APPENDIX 7: COMMENTS AND RESPONSES ON PROPOSED 2016 MONITORING NETWORK PLAN, REVISION 1

Re: 2016 Monitoring Network Plan, Revision 1 (November 15, 2016)

Figure 1. Modeled SO₂ design values in the vicinity of the Rush Island Energy Center.

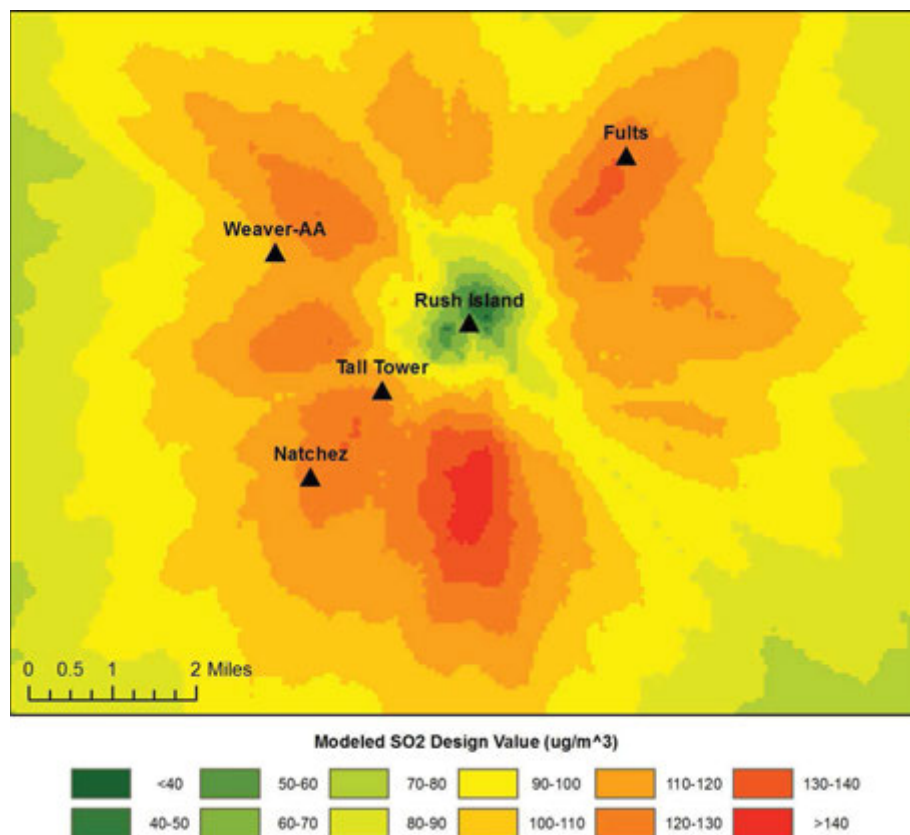
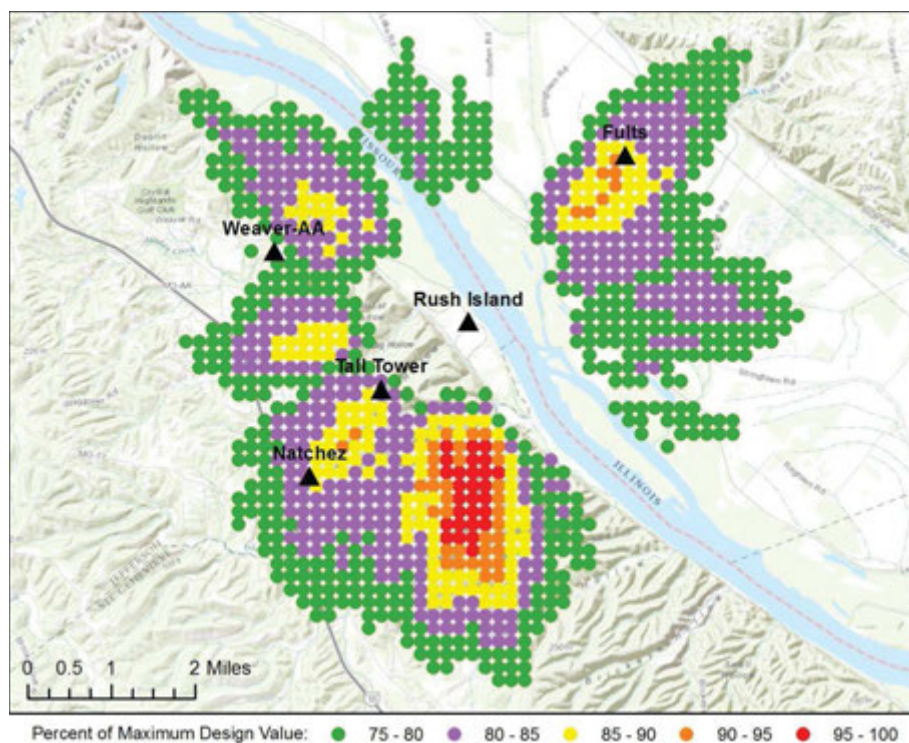
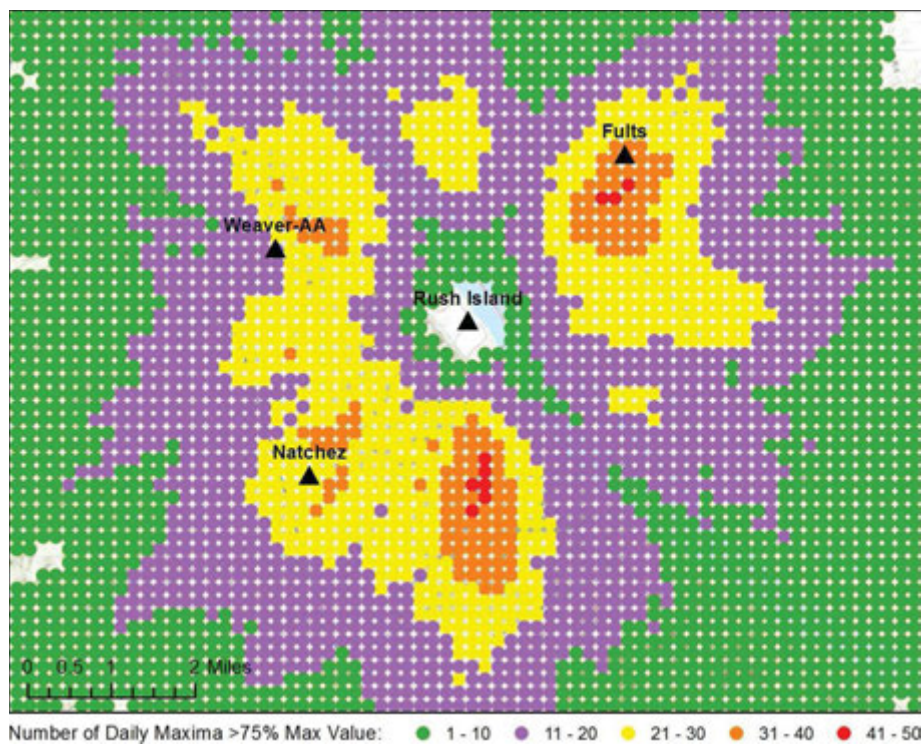
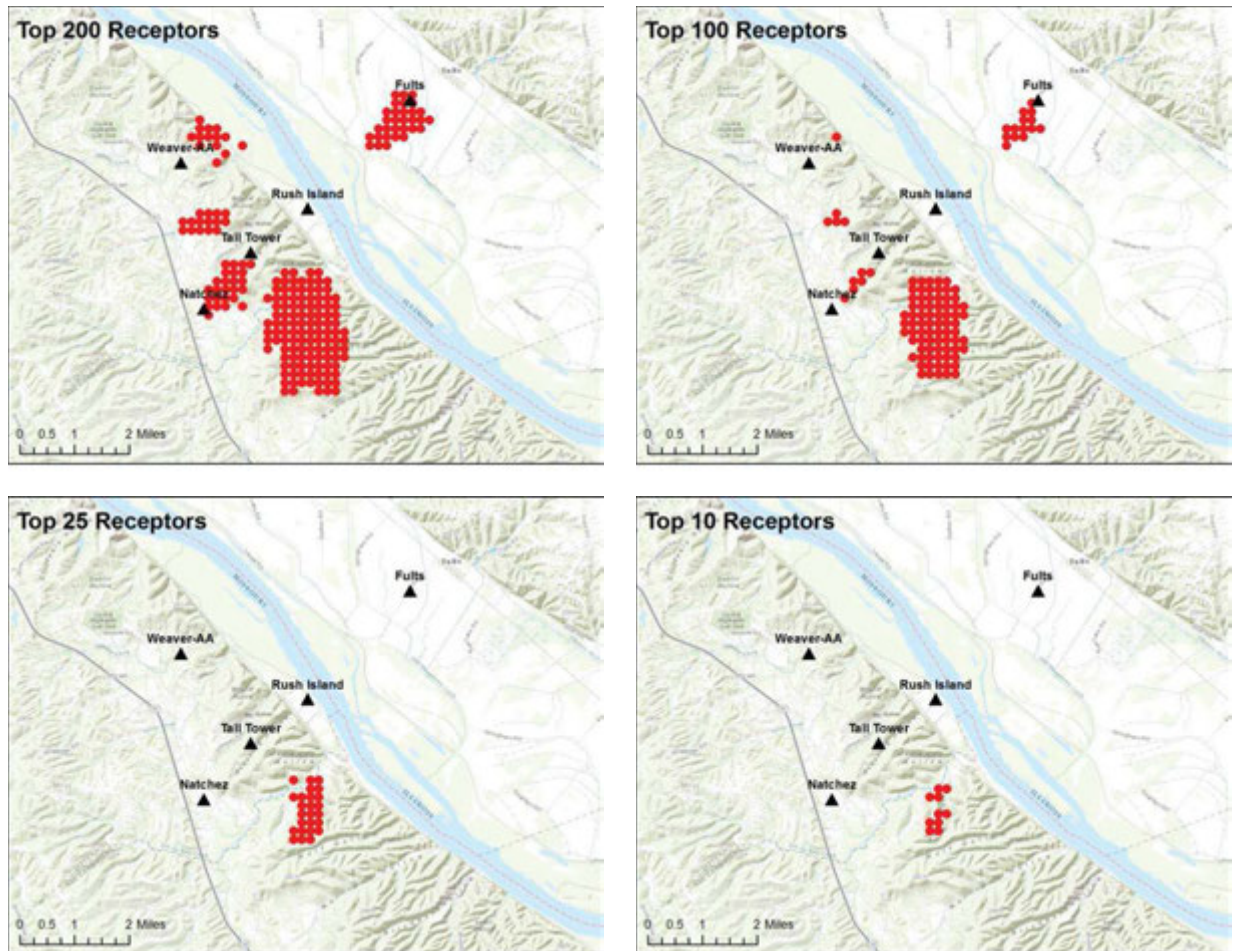
Figures 1 through 4 below show the results of Ameren’s modeling, which we derived using model input files provided by DNR. Figure 1 shows modeled SO₂ design values in the vicinity of the plant; Figure 2 shows receptors with modeled design values greater than or equal to 75 percent of the maximum modeled design value (146.1 ug/m³); Figure 3 shows the number of times the model-derived maximum daily 1-hour concentration exceeded 75 percent of the maximum modeled design value at each receptor; and Figure 4 shows the receptors with the top 200, 100, 25, and 10 modeled design values. The locations of the plant and the proposed Fults, Natchez, and Weaver-AA SO₂ monitoring stations and the proposed Tall Tower meteorological monitoring station are shown on all figures for reference.

Figures 1 through 4 all reveal a strikingly similar pattern regarding the areas where peak 1-hour SO_2 concentrations are expected to occur around the Rush Island Energy Center. There is a large area due south of the plant where modeled design values are the highest (in excess of 95 percent of the maximum modeled design value), where modeled maximum daily 1-hour concentrations frequently exceeded 75 percent of the maximum modeled design value, and where over half of the top 200 receptors (including all of the top 25 and three quarters of the top 100) are located. There are also four other areas where modeled design values are slightly lower but still very high (in excess of 85 percent of the maximum modeled design value), where modeled maximum daily 1-hour concentrations frequently exceeded 75 percent of the maximum modeled design value, and where the rest of the top 200 receptors are located. These four areas, located northeast, northwest, west, and southwest of the plant, plus the area south of the plant where modeled design values are the highest, are where Ameren's modeling predicts peak 1-hour SO_2 concentrations are expected to occur. Monitoring stations located in these areas would have the greatest chance of identifying peak SO_2 concentrations in ambient air, which is the primary objective of source-oriented monitoring and an absolute necessity when monitoring to assess

Figure 5. Modeled design values, receptors with design values ≥ 75 percent of the maximum modeled design value, and proposed monitoring station locations.

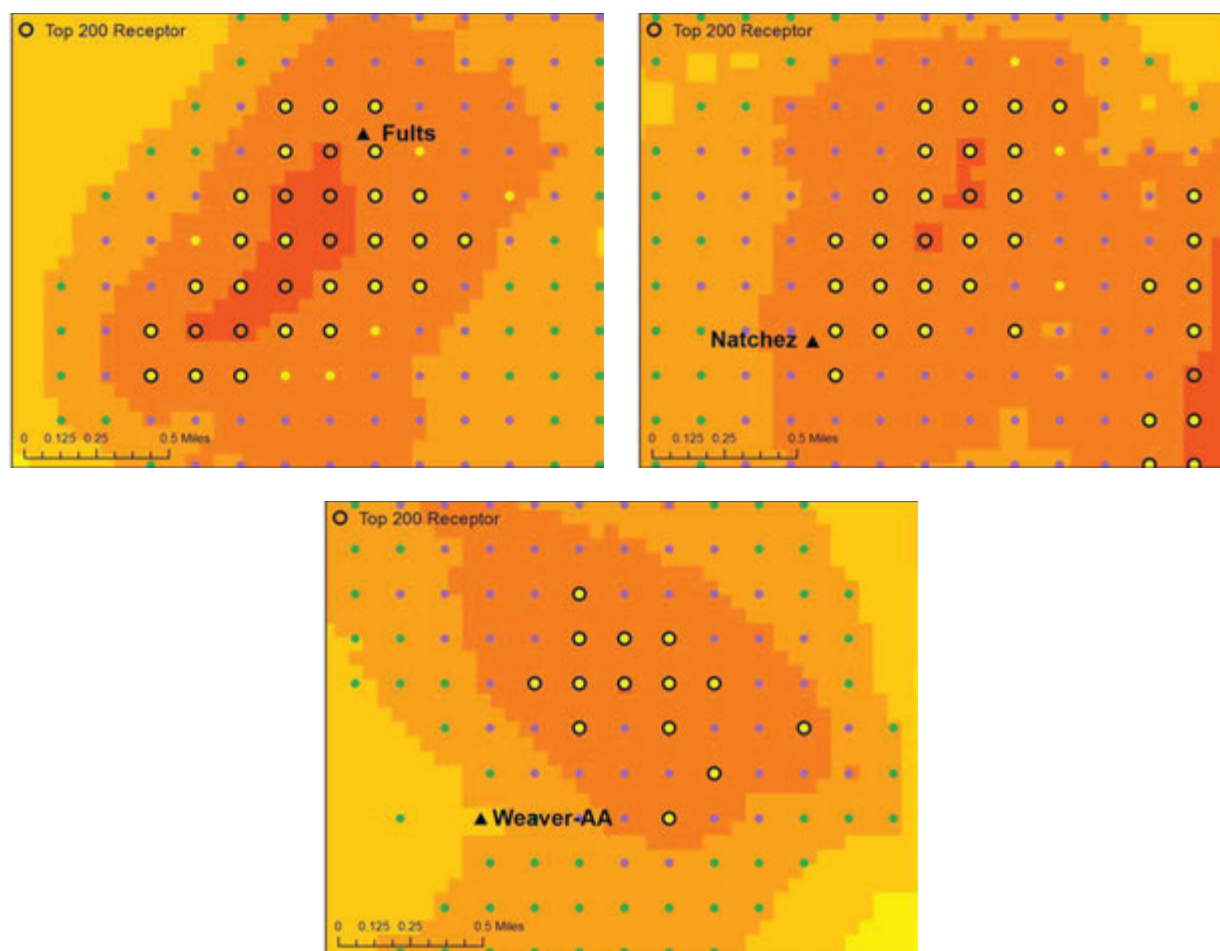
Furthermore, two of the proposed monitoring stations – Fults and Natchez – are located near but outside of areas of modeled peak concentration/high frequency instead of near the center of such areas, where concentrations are expected to be higher. The third proposed station – Weaver-AA – is located entirely outside of modeled peak concentration/high frequency areas. Figure 5 shows the locations of the proposed monitoring stations on a hybrid basemap comprised of Figures 1 (modeled design values) and 2 (receptors with modeled design values ≥ 75 percent of the maximum design value). Receptors that are among the 200 with the highest modeled design values are outlined for reference. All three monitoring stations could easily be sited in areas where higher 1-hour SO₂ concentrations are expected to occur with greater frequency, thereby increasing their chances of detecting any NAAQS exceedances that might occur around the Rush Island Energy Center. As discussed below, we urge DNR to consider these proposed optimized locations in lieu of Ameren's proposed Fults, Natchez, and Weaver-AA locations.

Fults – Of the three proposed monitoring stations, the Fults monitoring station is closest to an area where peak 1-hour SO₂ concentrations are expected to occur. However, moving the monitor less than one kilometer southwest of its current location would move it from an area with modeled design values in the 120-130 ug/m³ range to an area with modeled design values in the 130-140 ug/m³ range and place it near the center of a small group of receptors with modeled design values equal to 90-95 percent of the maximum modeled design value (the receptors

Figure 6. Current and optimized locations of the Fults, Natchez, and Weaver-AA monitoring stations

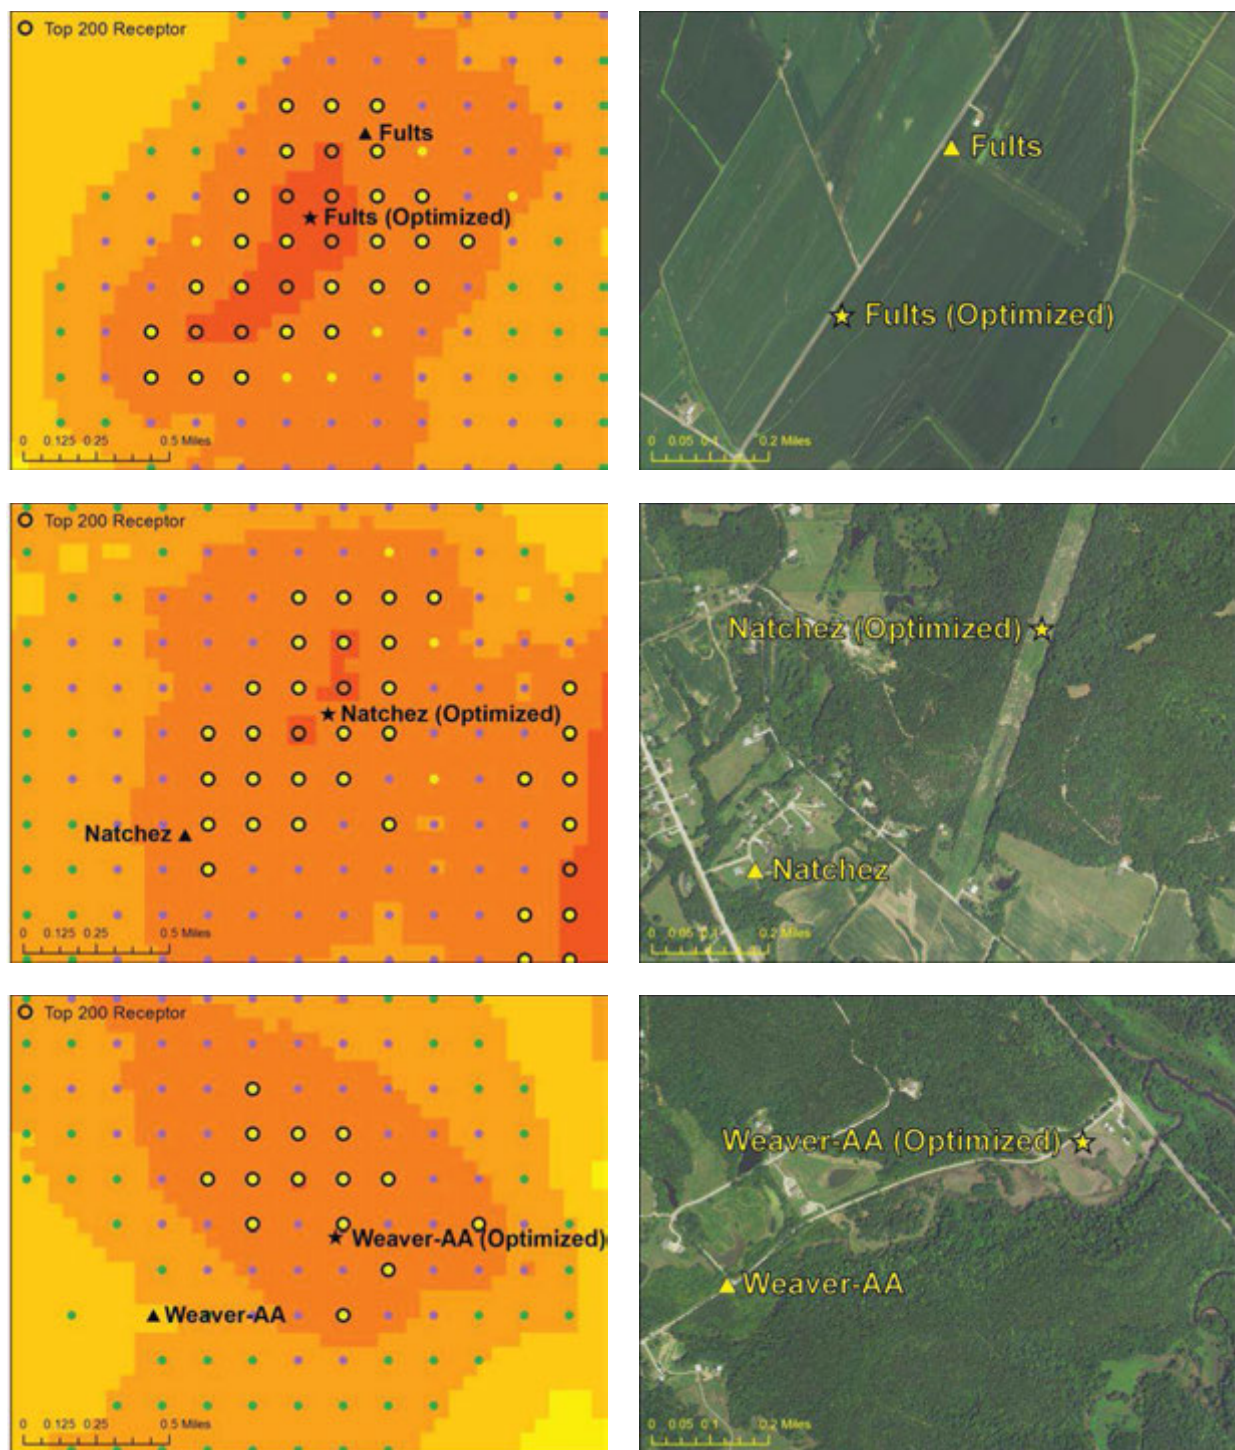
Figure 6 compares the locations of Ameren’s proposed Fults, Natchez, and Weaver-AA monitoring stations with optimized locations more likely to record maximum SO₂ concentrations in the area.

We urge DNR to reject the proposed monitoring sites and require Ameren to add a monitoring station in the highest concentration area due south of the plant as well as to relocate the proposed Fults, Natchez, and Weaver-AA monitoring stations to the optimized locations shown in Figure 5. We also urge DNR to require Ameren to 1) rerun the air dispersion model described in the report using Rush Island's actual hourly emissions; 2) evaluate the effects of nearby interactive sources (including, at a minimum, River Cement, St. Gobain Containers, Holcim, Mississippi Lime, Dynegy's Baldwin Energy Complex, and Ameren's Meramec Energy Center) on modeled peak concentration/high frequency areas; and 3) evaluate the appropriateness of using meteorological data from the Cahokia, Illinois airport instead of Doe Run Herculaneum given DNR's determination that the latter is more representative of the modeled area.⁷ We further urge DNR to require any necessary adjustments to the proposed monitoring network based on the results of these analyses.

Figure 1. Modeled peak concentration areas near Ameren's Labadie plant.

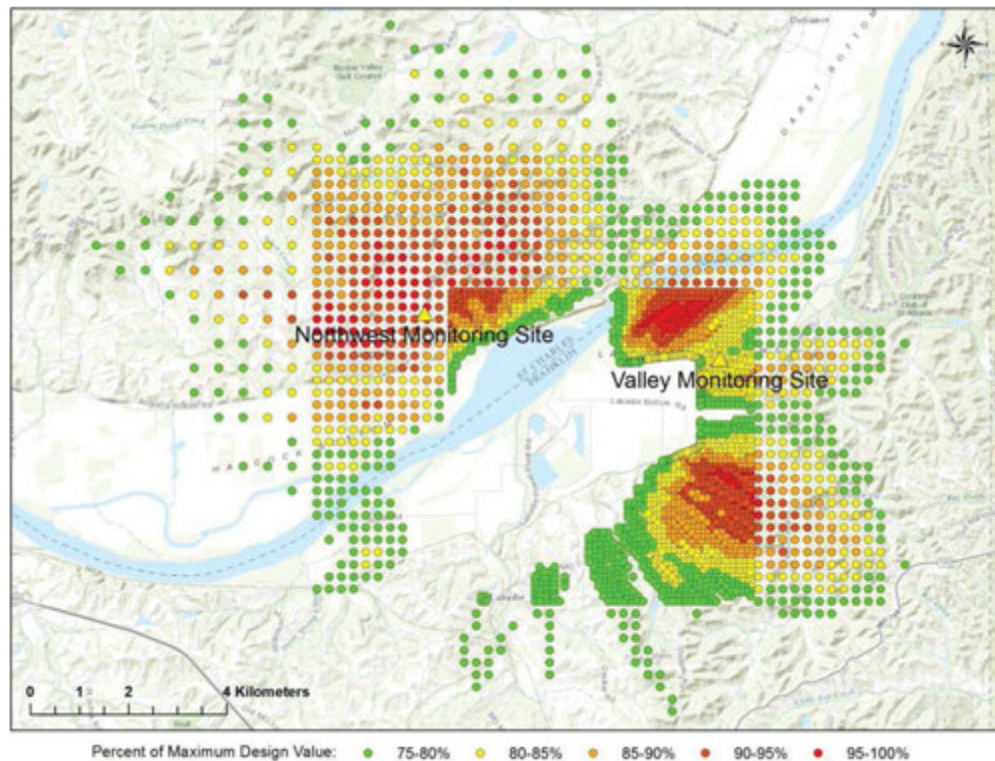
In our April 13, 2015 comments to DNR on Ameren’s proposed new Labadie monitoring sites, attached as Exhibit 1, we demonstrated that one of the proposed sites – the Valley site – is not located in any of the areas where Ameren’s modeling predicts peak SO₂ concentrations are expected to occur. Ameren’s modeling identified three distinct areas where the highest SO₂ concentrations are expected to occur and where high concentrations are expected to occur most frequently. These areas are located northwest, northeast, and southeast of the plant and are shown in Figure 1 below. However, only one of the two proposed Labadie monitoring sites – the Northwest site – is located in one of these peak concentration areas (the one located northwest of the plant). The Valley site is located between the other two peak concentration areas, in an area where the modeled concentration is only about 80 percent of the maximum concentration predicted by the model. As a result, it is unlikely to capture maximum ambient SO₂ concentrations and should be relocated to the peak concentration area northeast of the plant.

therefore more reliable than Ameren's modeling. While DNR concluded that the proposed sites are properly located in areas where peak SO₂ concentrations are expected to occur, there is a significant flaw in DNR's analysis that, when corrected, confirms that the Natchez and Weaver-AA sites are located outside of peak concentration areas and should be relocated.

Figure 5. Ameren's proposed SO₂ monitoring sites relative to DNR's polygons. Peak concentration areas (>90 ug/m³) are shaded red.

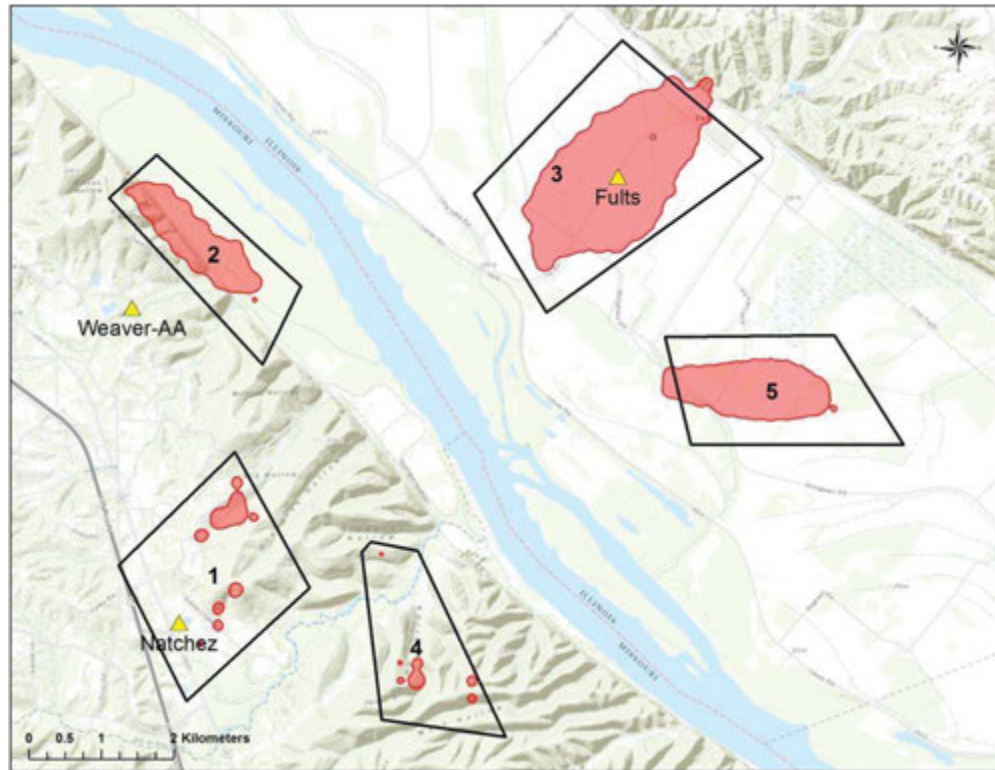
The locations of Ameren's proposed SO₂ monitoring sites – dubbed Fults, Natchez and Weaver-AA – relative to DNR's polygons are shown in Figure 5 below. Of the three proposed sites, only the Fults site, which is inside the peak concentration area within polygon 3, is properly located. The Weaver-AA site, which Figure 2 of Monitoring Network Plan Appendix 5 incorrectly shows being within polygon 2, is actually located outside of it based on the site coordinates provided in Plan Appendix 1. Hence it is not properly located. Nor is the Natchez site, which should be located within polygon 5 instead of polygon 1 because polygon 5 has higher modeled impacts.

Because they are not properly located, neither the Natchez nor Weaver-AA monitoring sites will adequately represent Rush Island's SO₂ air quality impact. Therefore, both sites should be relocated. The Weaver-AA site should be located inside the peak concentration area within polygon 2 and the Natchez site should be located inside the peak concentration area within polygon 5 as shown in Figure 6 below. Alternatively, the Natchez site could be moved inside the peak concentration area within polygon 1 and a fourth monitor added inside the peak concentration area within polygon 5 as shown in Figure 7 below. The recommended monitor locations shown in Figures 6 and 7 are easily accessible and appear to meet EPA siting criteria and have ready access to power.

Figure 1. Expected peak concentration areas per Ameren's original modeling.

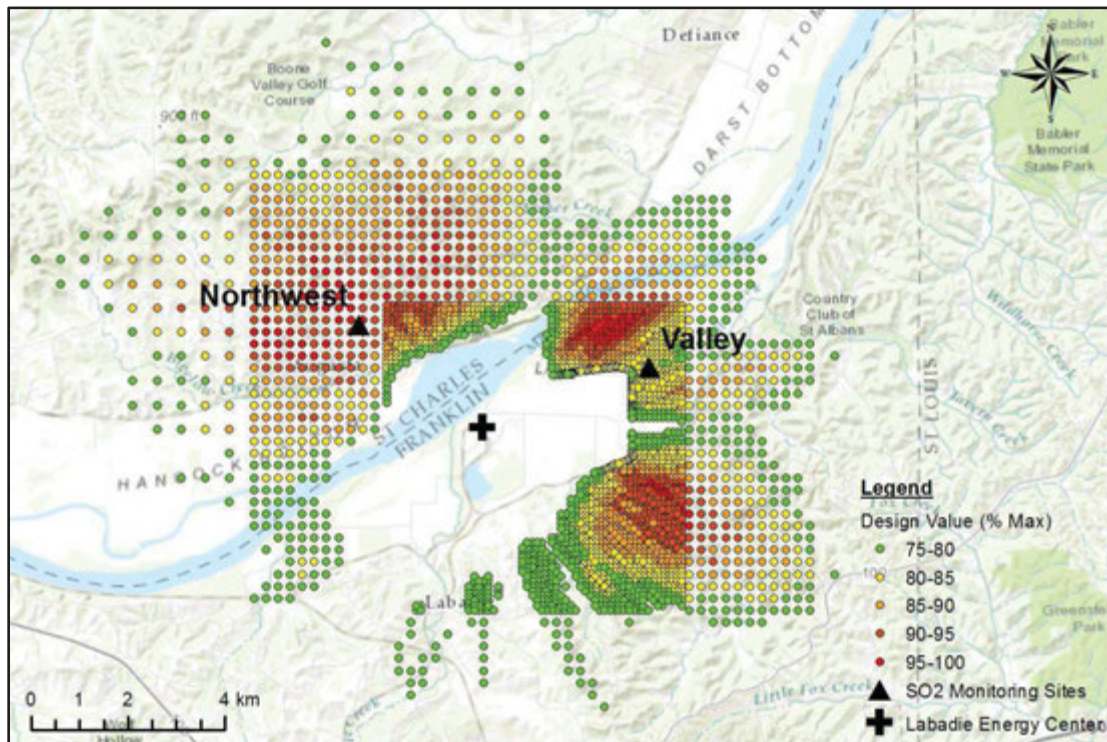
- Ameren's original modeling to site the monitors identified three distinct areas where peak 1-hour SO₂ concentrations are expected to occur. These areas are located northwest, northeast, and southeast of the plant and are shown in Figure 1. However, only one of the monitors – the Northwest monitor – is located in one of these areas. No monitor is located in either of the other two peak concentration areas. The Valley monitor is located between the two unmonitored peak concentration areas, at a site where the modeled concentration is approximately 20 percent lower than in the peak areas.
